Product Change Notice (PCN)

PCN Number: **PCN-0451165R-01**

Product(s) Affected: **PJ-041H**

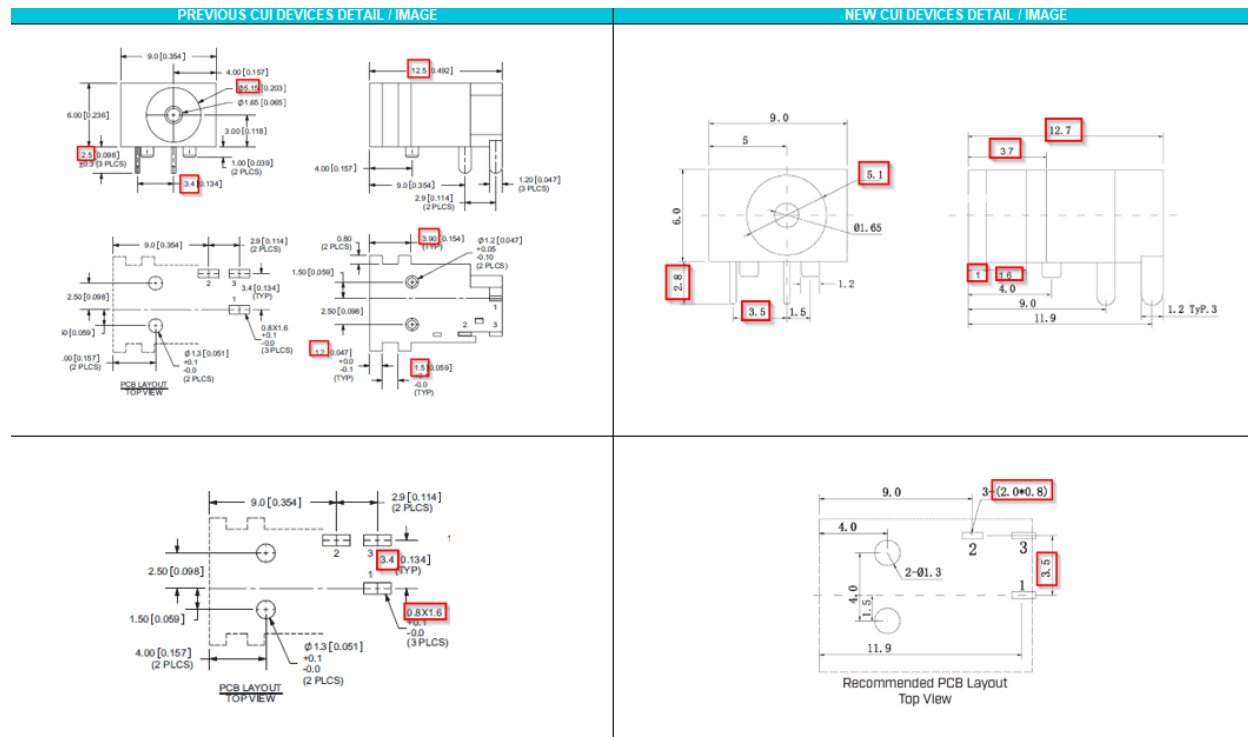
Description of Change: **Mechanical, electrical, and material changes as shown below:**

MATERIAL	PLATING
center pin	brass	silver
terminal 1	brass	silver
terminal 2	copper alloy	silver
terminal 3	brass	silver
plastic	PA66

DESCRIPTION	MATERIAL	PLATING/COLOR
center pin	brass	silver
terminal 1	brass	silver
terminal 2	C5191 phosphor bronze t=0.30	silver
terminal 3	C5210 brass t=0.30	silver
housing	PAB6 (LJL94V-0)	black
